**TRANSMITTAL OF DOCUMENT CHANGE NOTICE #1486, FERNALD CLOSURE PROJECT,
WASTE PIT PROJECT, CLOSURE OF CLEARWELL AND PROCESS WATER ROUTING TO
STORMWATER MANAGEMENT POND**

Clearwell Closure Plan – 08JUN04

Engineering / Document Change Notice

Shaw Project No. 773481 / FF No. 98SC000001		Project Name: WPRAP	PCP: N/A
Subject: Process Water Routing to SWM Pond			
Type of Change: ECN _____ DCN <u> X </u>	Change Class: Class 1 _____ (PCP Req'd) Class 2 _____ (PCP Req'd) Class 3 <u> X </u> (Minor Mod)	Change Number: 1486	Issue Date: 06/04/04 Page <u> 1 </u> of <u> 3 </u>
Reason for Change: Reference DCN 1466 04/08/04 and DCN 1475 05/21/04. Closure of the Clearwell and continued operations require the utilization of the SWM Pond as the primary collection point for contact surface water from excavation, blowdown, and building sumps.			
Description of Change: In DCN 1466, a 2 nd submersible pump (P-9081) was added to the truckwash settling basin in addition to P-9080. P-9080 and P-9081 have 400-500ft 4" HDPE discharges direct to the clearwell. 12"PW-9021-UW, which delivers surface water from the plant and haul road sumps to the clearwell was re-directed from the point near the BSL where it

DCN 1486: Before/After Stormwater Flow

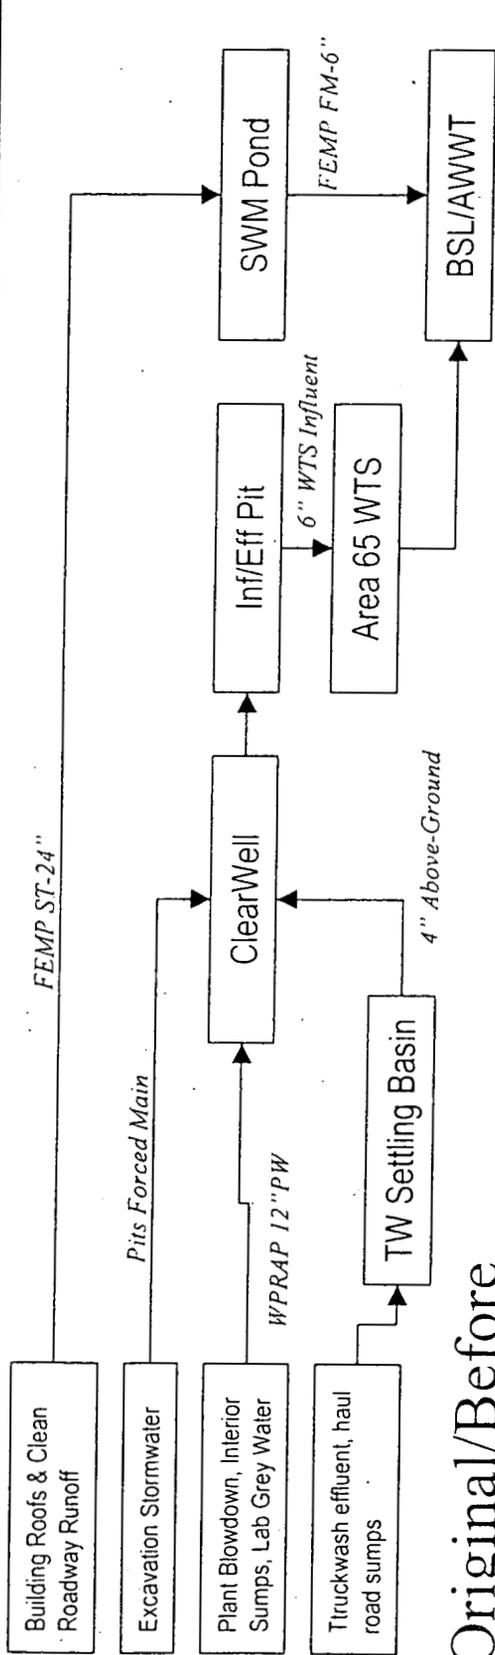
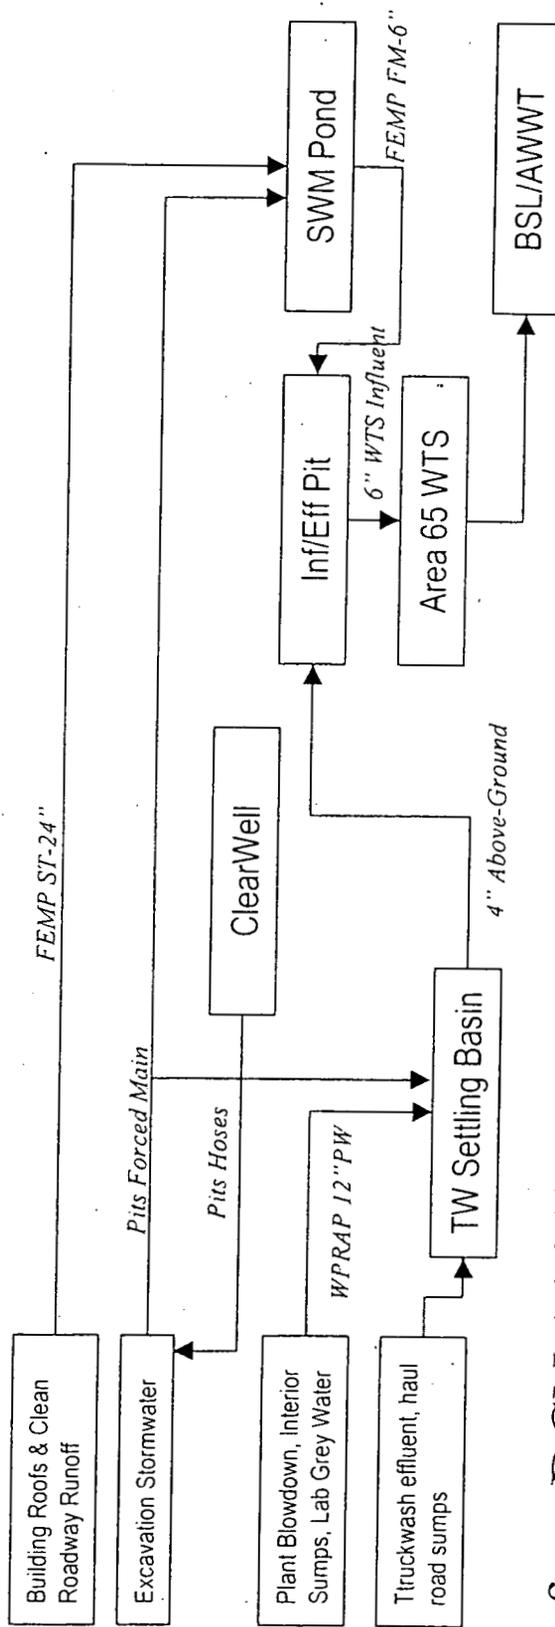
- D-90-10-001: Added Truckwash Basin, Consolidated Clearwell flows to either Truckwash Settling Basin or SWM Pond, new Stream 930.
- D-90-10-002: Now 2 sheets, 2nd sheet reflects current conditions and expected as of Dryer Cessation - 1st page left unchanged (original design)

DESIGNED BY	SKZ	CHECKED BY	BAH	7/9/99	REVISION
DRAWN BY	JMH	APPROVED BY	JAM	7/9/99	
DATE	7/9/99	DWG. SCALE	NONE		3
IT PROJECT NO.	773481	DRAWING NO.	D-05-11-002

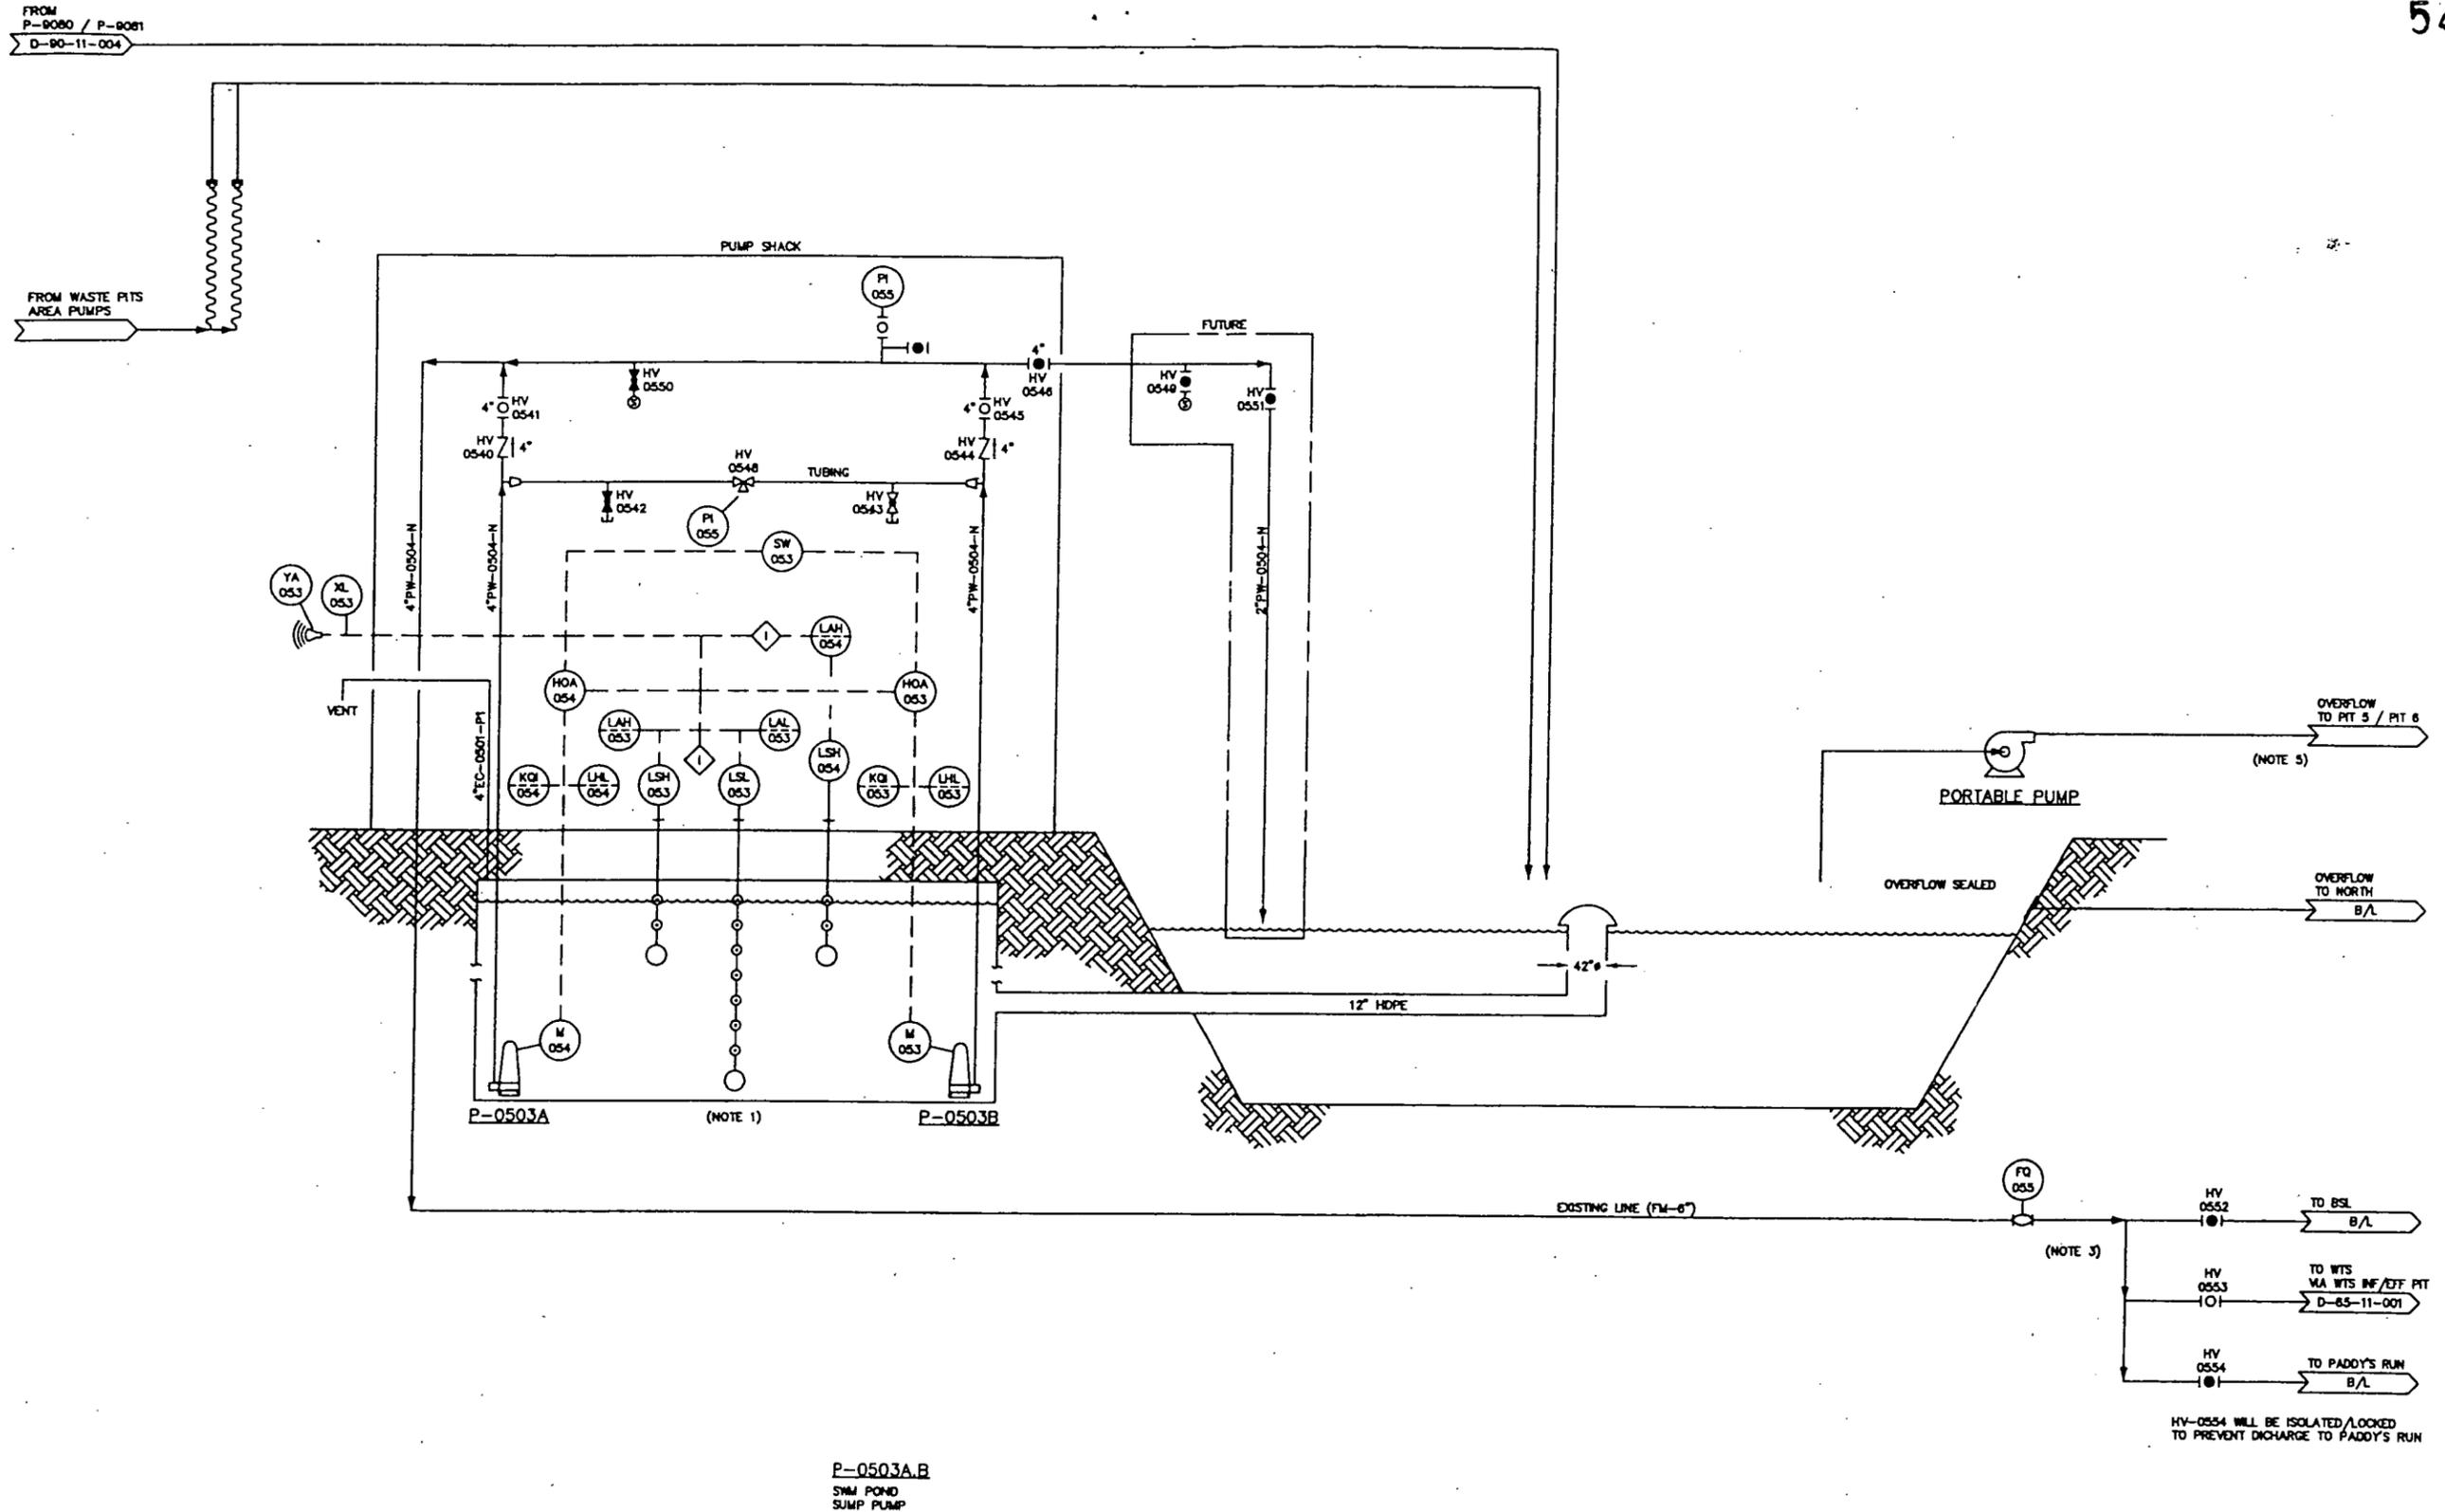
- D-05-11-002: Added P-9080/81 influent to SWM Pond, added seal of overflow, added manual pump for overflow relief, modified FM-6" tie-in valve to show D-65-11-001.

1. WELL DIMENSIONS ARE 80"x24"x20'-0".
2. PUMP SHACK IS LABELED 98-256-ASVP.
3. UNDERGROUND VALVES AND FLOWMETER . (VALVES ARE NORMALLY CLOSED)
4. DCN 1486, 06/04/04: ADDED D-65-11-001 AS DESTINATION FOR HV-0553 EFFLUENT TO ROUTE SWM POND EFFLUENT DIRECT TO WTS
5. OVERFLOW CAN BE MANUALLY PUMPED TO PITS AT SWM POND OR MAY BE PUMP VIA P-0503 A/B THROUGH THE WTS BACK TO THE WASTE PITS IF NEEDED.

DESIGNED BY	PWS	CHECKED BY	PA	2/1/99	REVISION
DRAWN BY	COB	APPROVED BY	JAN	2/1/99	
DATE	2/1/99	DWG. SCALE	NONE		6
IT PROJECT NO.	773481	DRAWING NO.	D-65-11-001

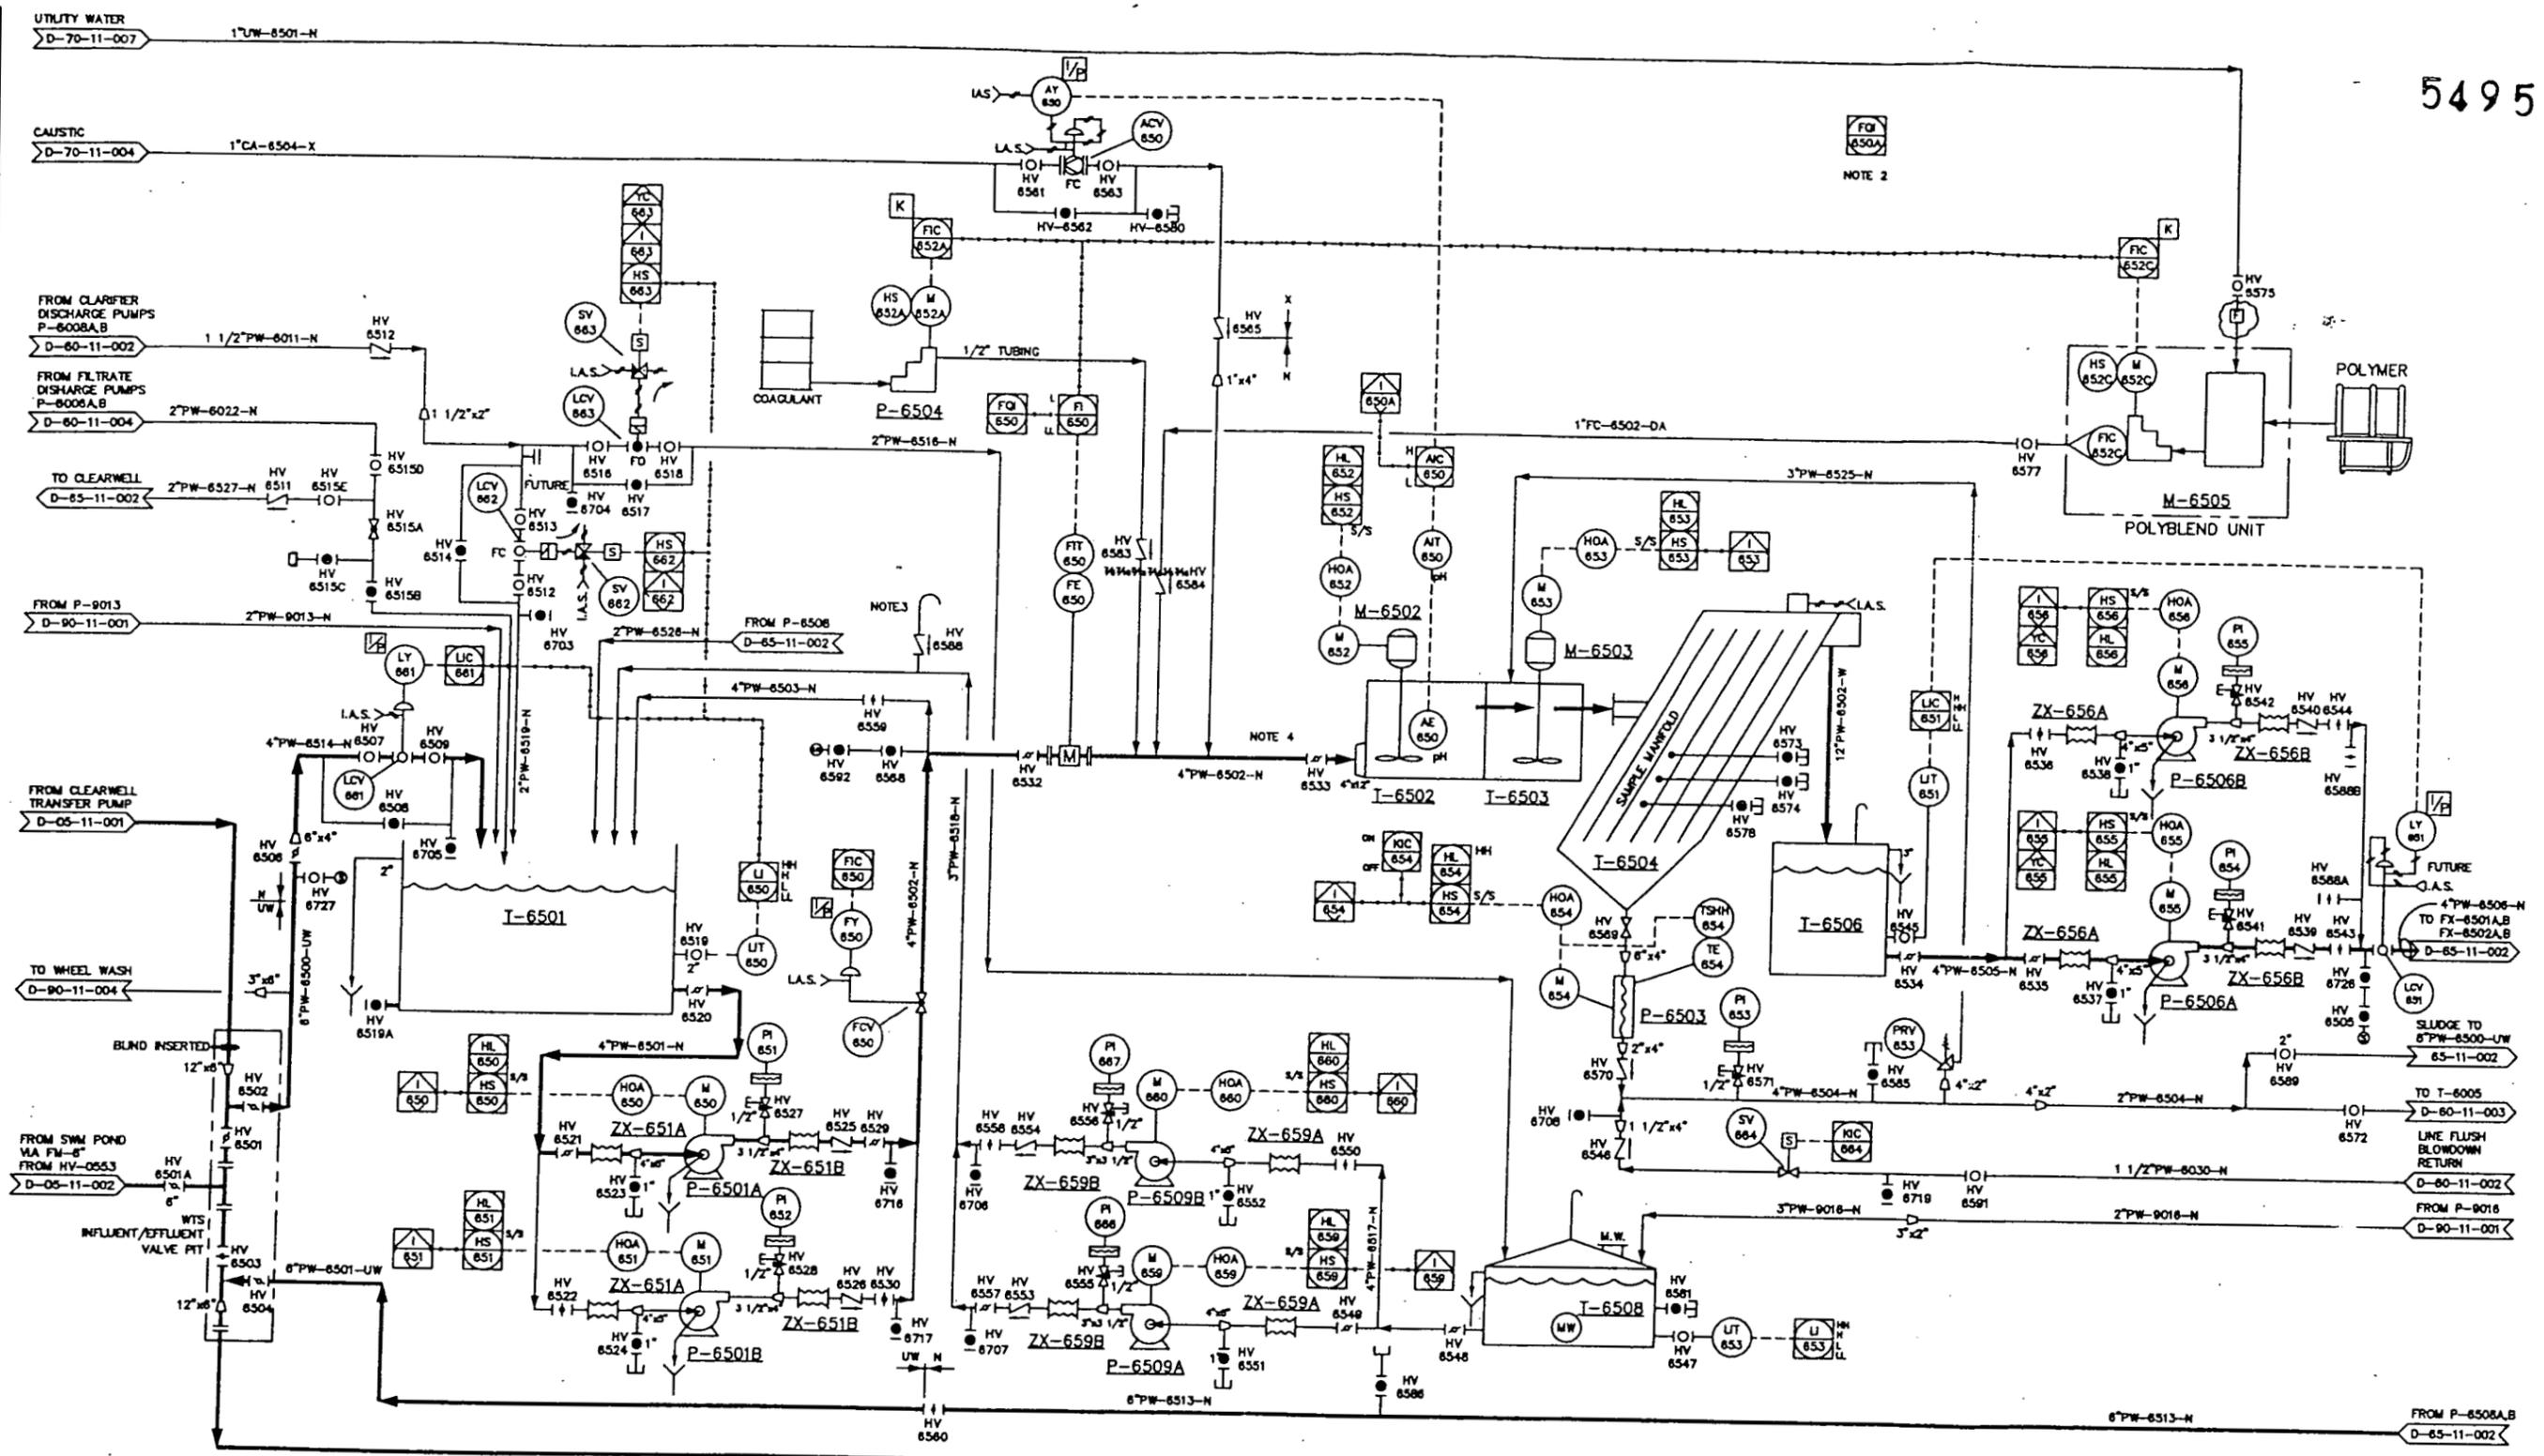
- D-65-11-001: removed FE-656, added line from D-05-11-002 and HV-6501A, showed a blind on Clearwell influent to valve station. Changed sludge reference, removing clearwell.
